Tender No. : <u>01/CS/2014</u>

Name of work : Supply, Installation, Commissioning, Facility Construction &

Maintenance of Drive-through Container Scanner (Road)

Subject : Clarifications to site related queries/issues raised in pre-bid meeting –

MUNDRA PORT SCANNER LOCATION MAP:

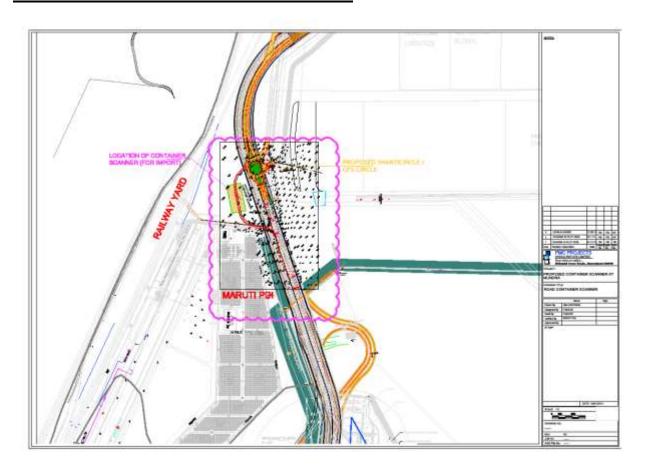
14	Entry	& exit roads	
		Will Port authorities construct the roads leading to and from the scanner facility?	Mundra Port has sought that the entry and exit roads to be constructed by the Bidder, however, these roads will be maintained by Mundra Port on long term basis, free of any charges and carries out relaying, whenever required.
			Scaled AutoCAD drawing of the zone of interest is attached.

Bore Hole Drawings of Mundra site:

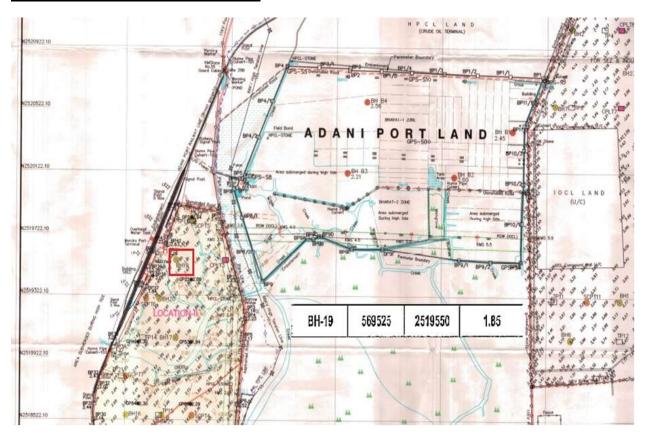
bodies to carry out the execution	out the execution activities at site. Bidder can carry						
		activities at site?	out the construction activities as per his arrangement.						
3	Exist	ing underground services							
		Are there any underground services/	There is no known existence of underground services,						
		cables, etc. running through the plot?	pipe lines, cables, etc. running through plot.						
4	Geo-	technical investigation							
		Are there any geo-technical report	Bore-hole location and data as available with Mundra						
		pertaining to the site for scanner	Port is attached. However, Bidder is advised to carry						
		installation available?	out geo-technical investigation of the scanner plot in						
			order to obtain the details of underground strata and						
			to decide on founding level and foundation design.						
5		dation
